Flyback and Buck Converter

Supplies Generations and Power-Up Sequence Control

Title		
Size	Number	Revision
A		
Date:	9/21/2026	Sheet of
File:	C:\Users\...\BUCK_CONVERTERS.SchDoc	Drawn By:

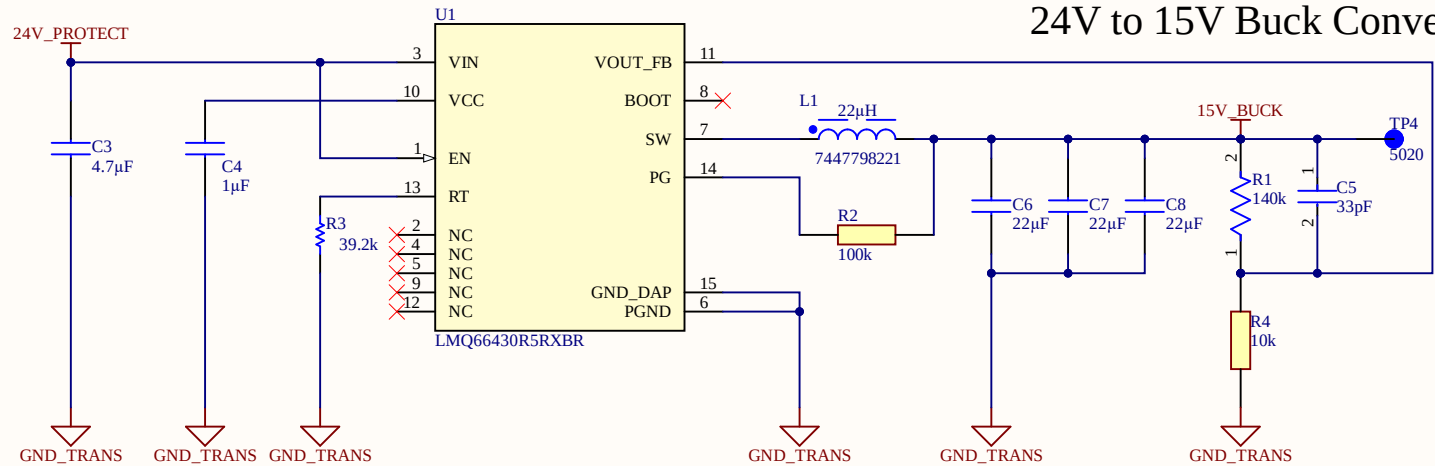
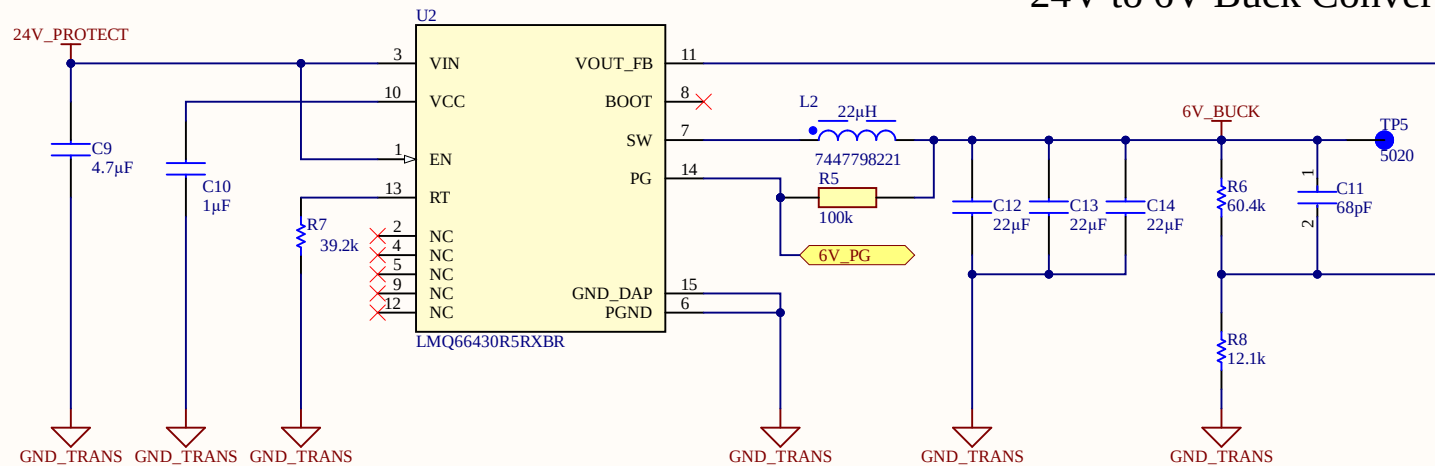
7k15 solved, 2.2uH (solved), 100k (solved), 22u (solved), 110k (fixed), 45.3k (fixed), 10p (solved), 10k (fixed)

4.7u, 1u need update

All related footprint should be fixed

Negative Supply Generation

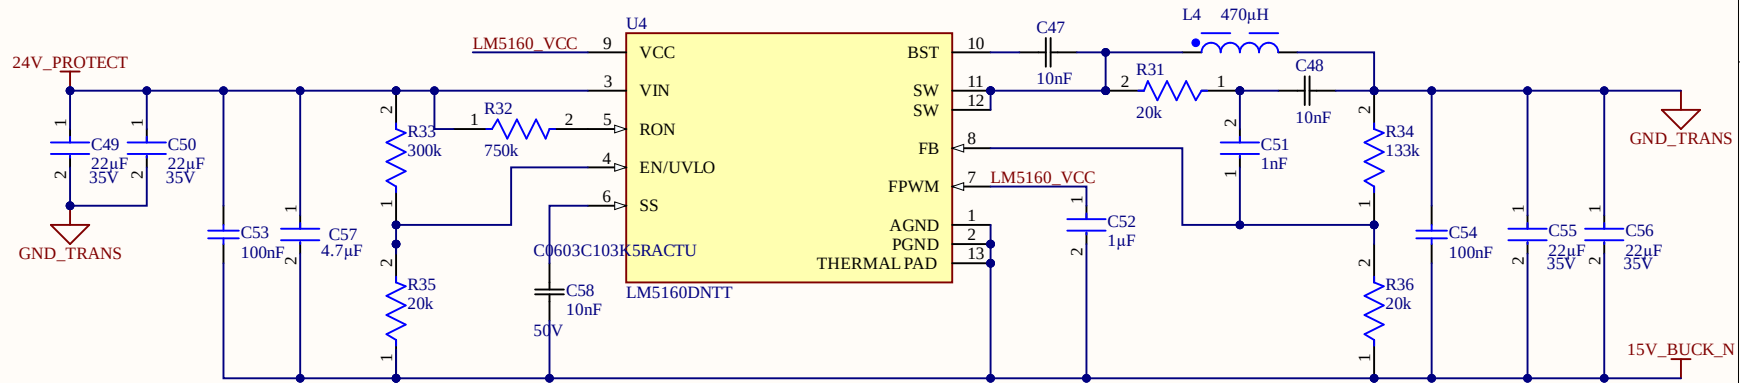
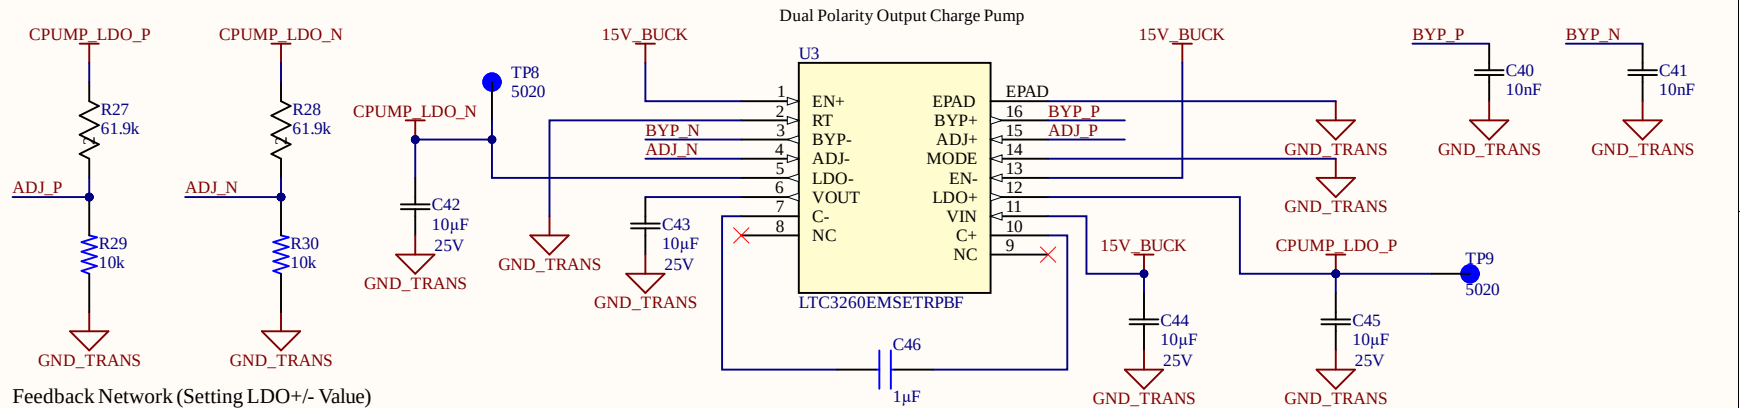
All related footprint should be fixed
The ADP7182 (Fixed Version) Negative LDO meets the 2% Accuracy Requirement for the TVEE Rail
